Final Drainage Report

**Double Spur Ranch  
Minor Subdivision  
12420 Meridian Rd,  
Colorado Springs, CO 80908**

Project #: 196518000

Add PCD File No.  
MS-235

**PANEL 0340G**

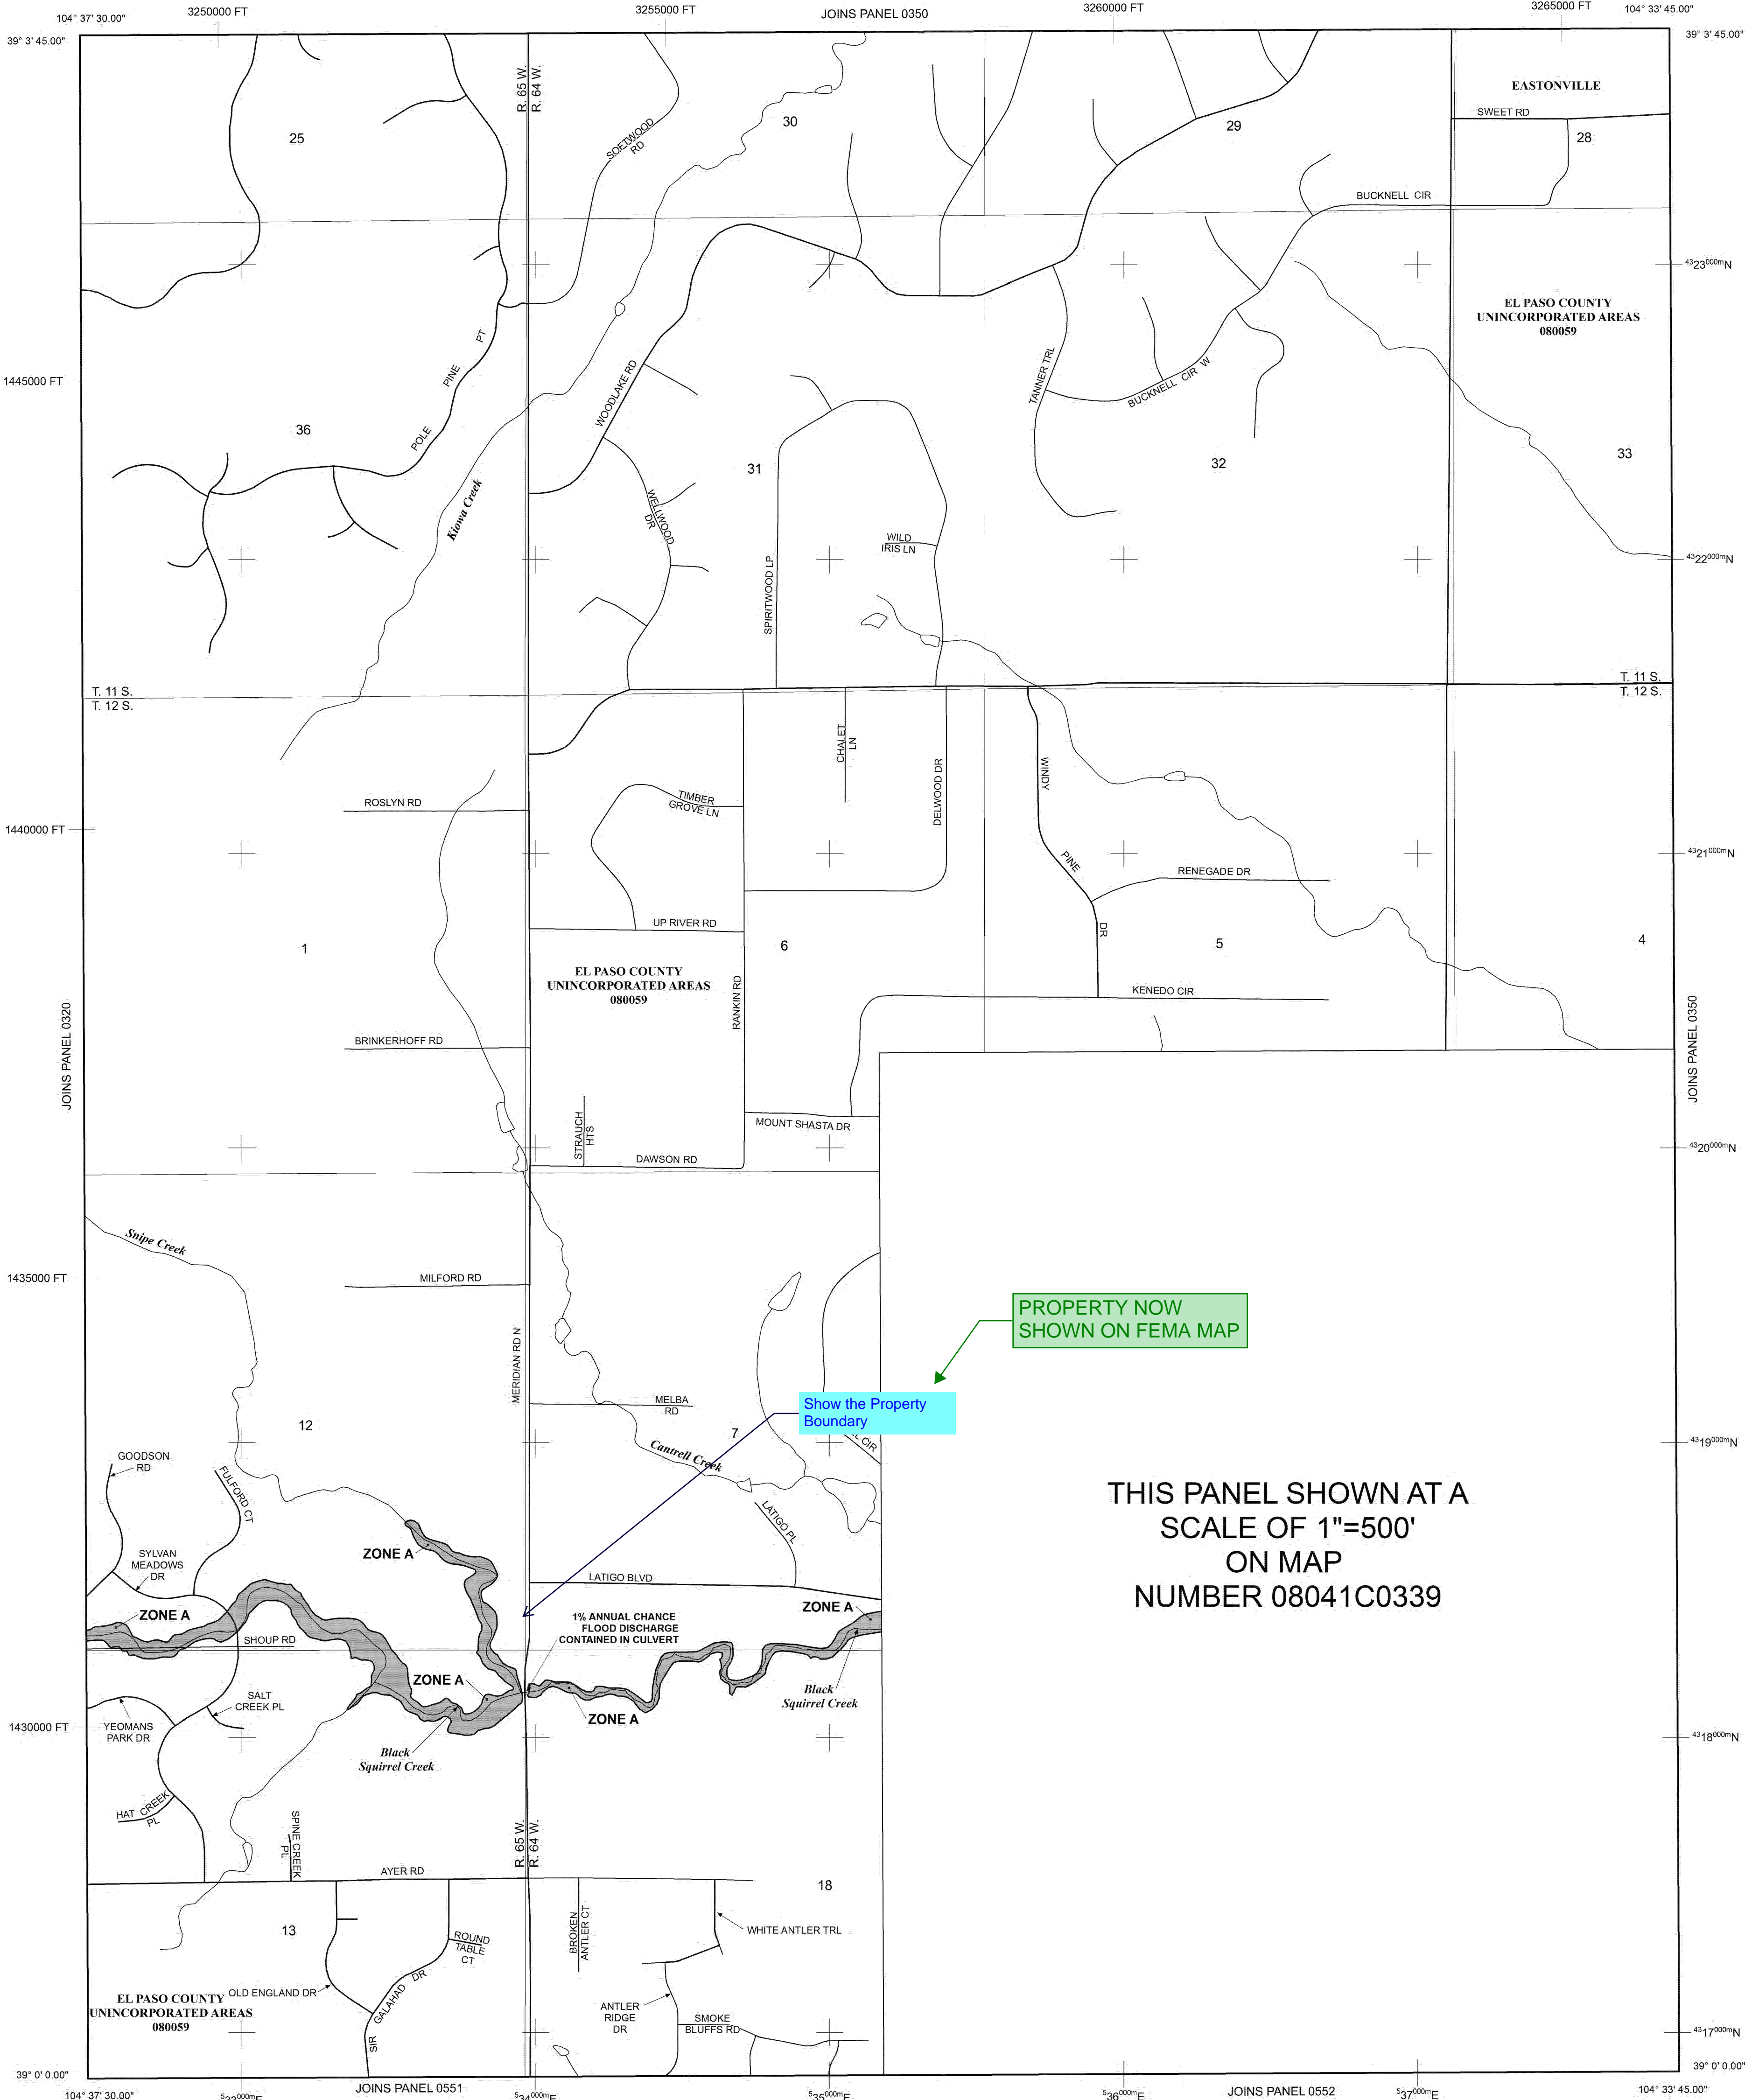
Show the Property Boundary

PROPERTY NOW SHOWN ON FEMA MAP

SHEET  
1

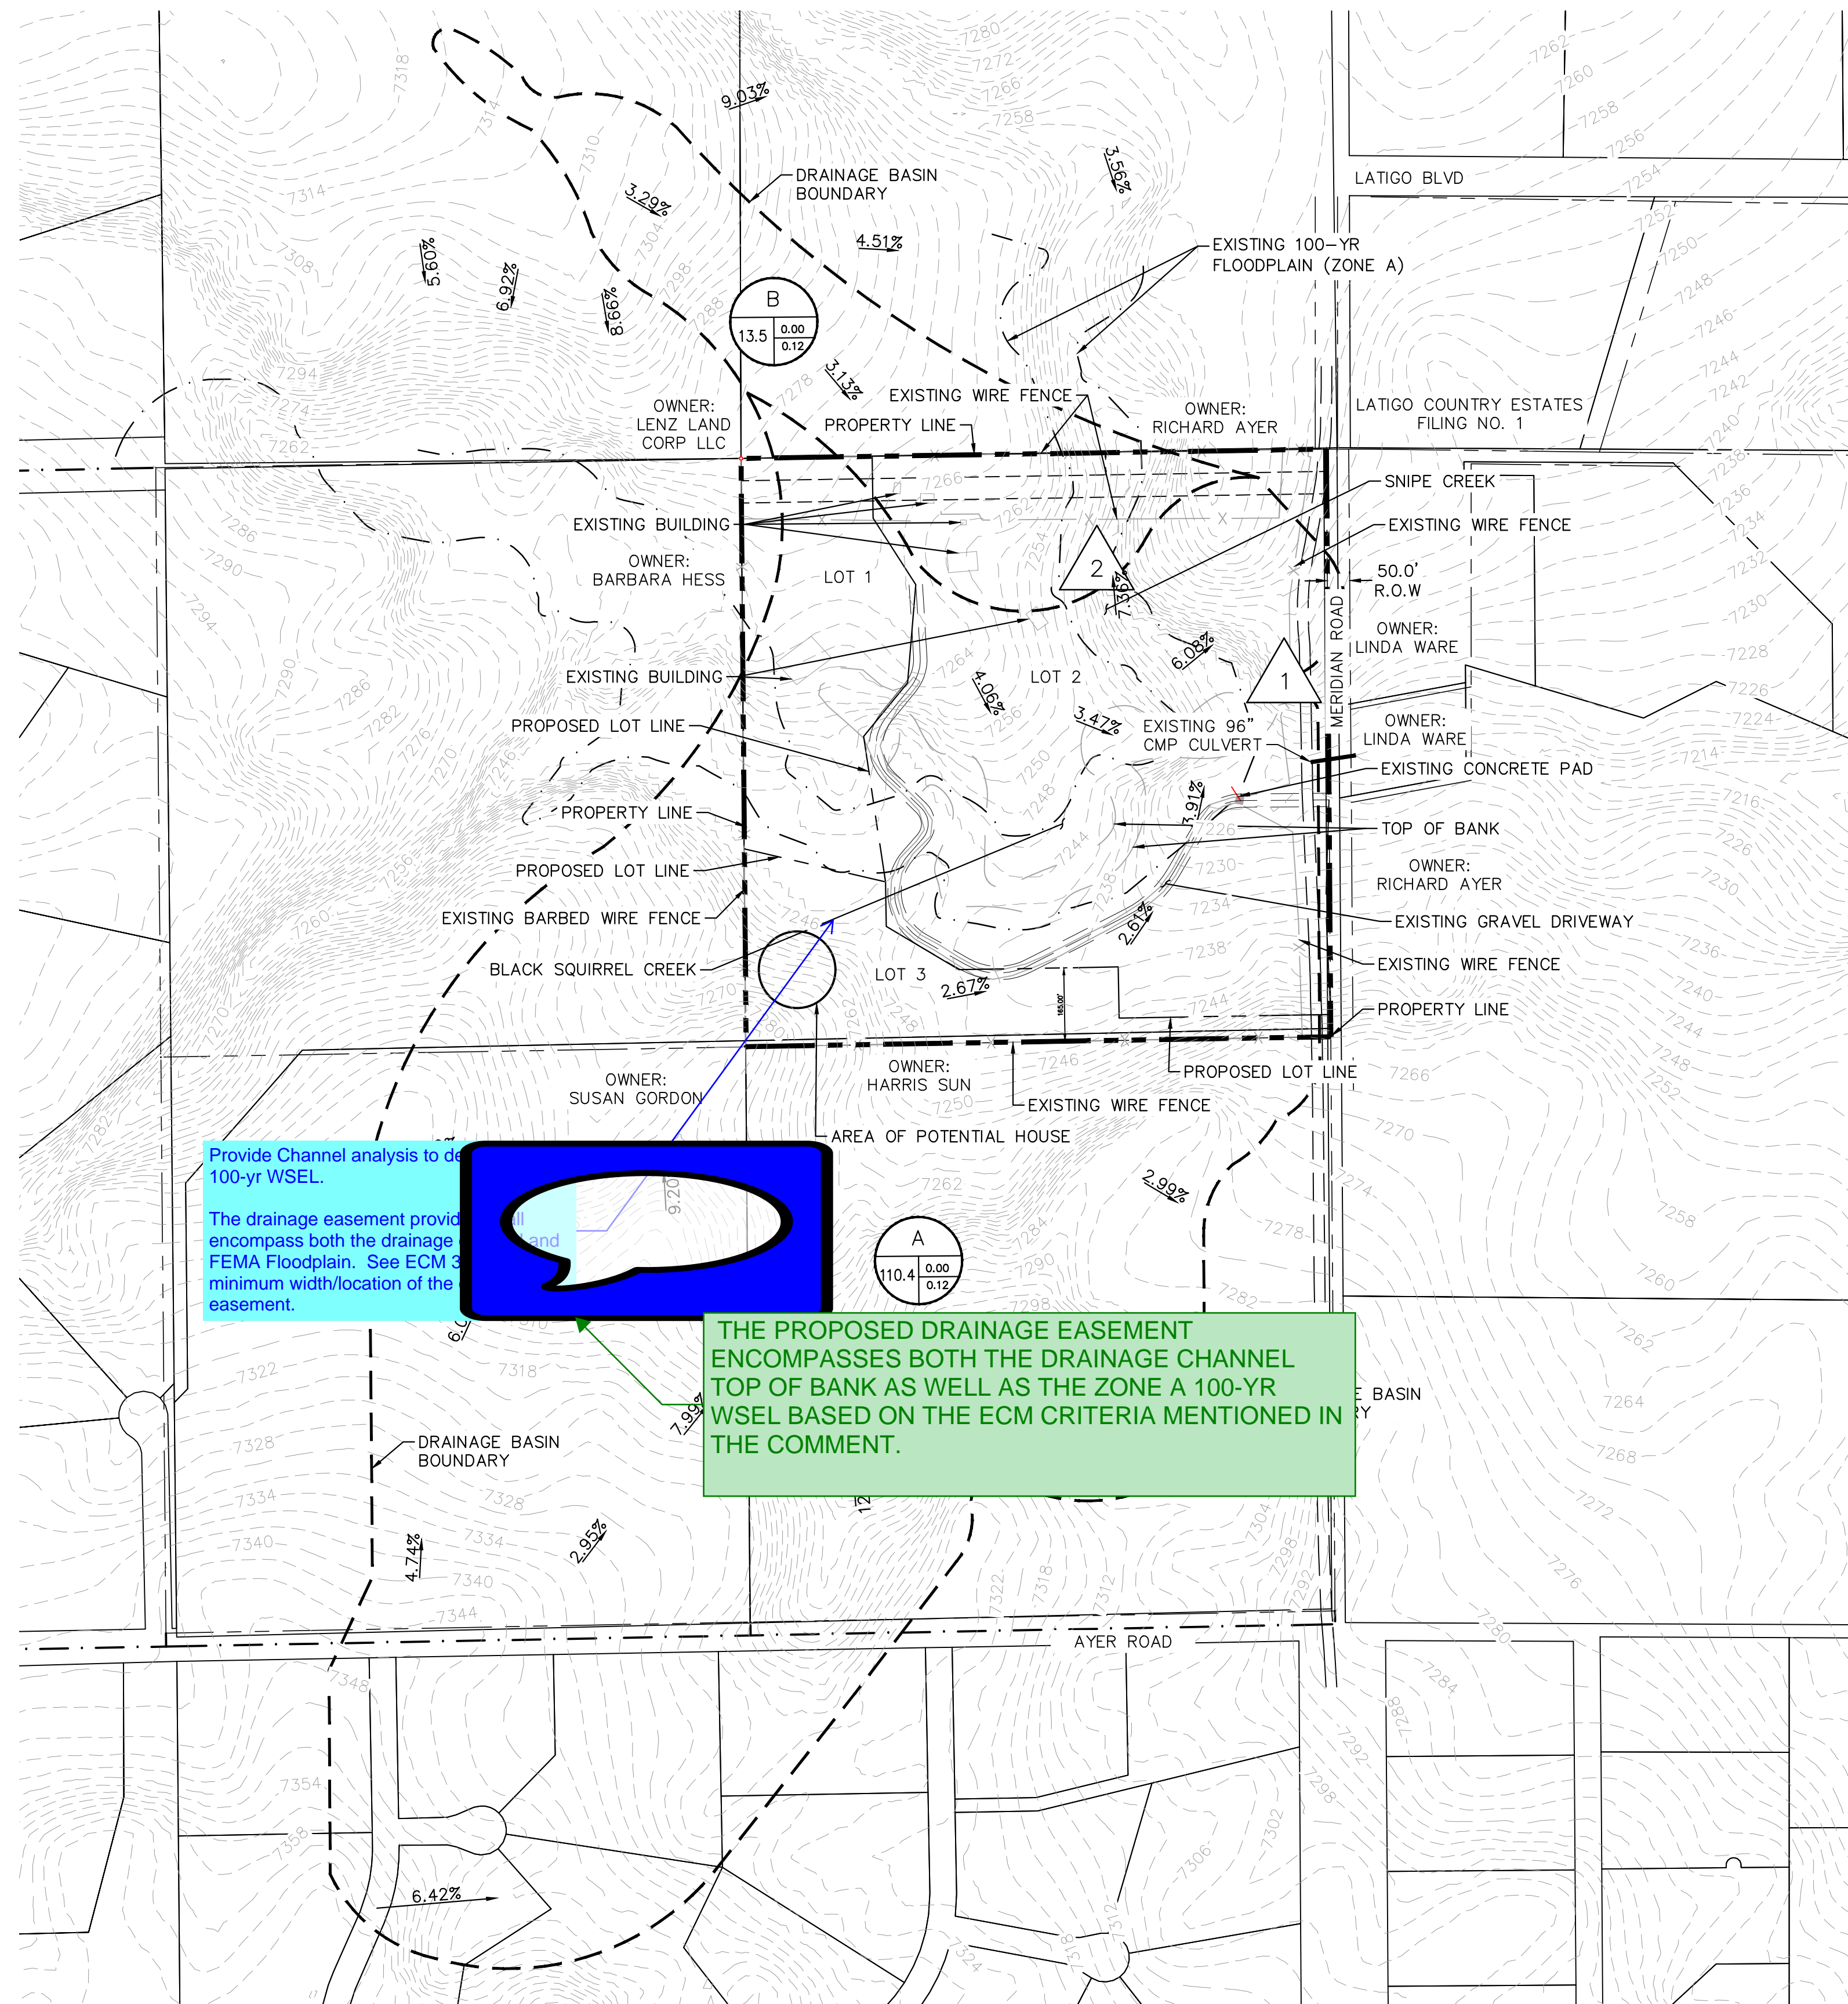
Provide Channel analysis to determine 100-yr WSEL.  
The drainage easement provided should encompass both the drainage channel and FEMA Floodplain. See ECM 3 for minimum width/location of the easement.

THE PROPOSED DRAINAGE EASEMENT ENCOMPASSES BOTH THE DRAINAGE CHANNEL TOP OF BANK AS WELL AS THE ZONE A 100-YR WSEL BASED ON THE ECM CRITERIA MENTIONED IN THE COMMENT.
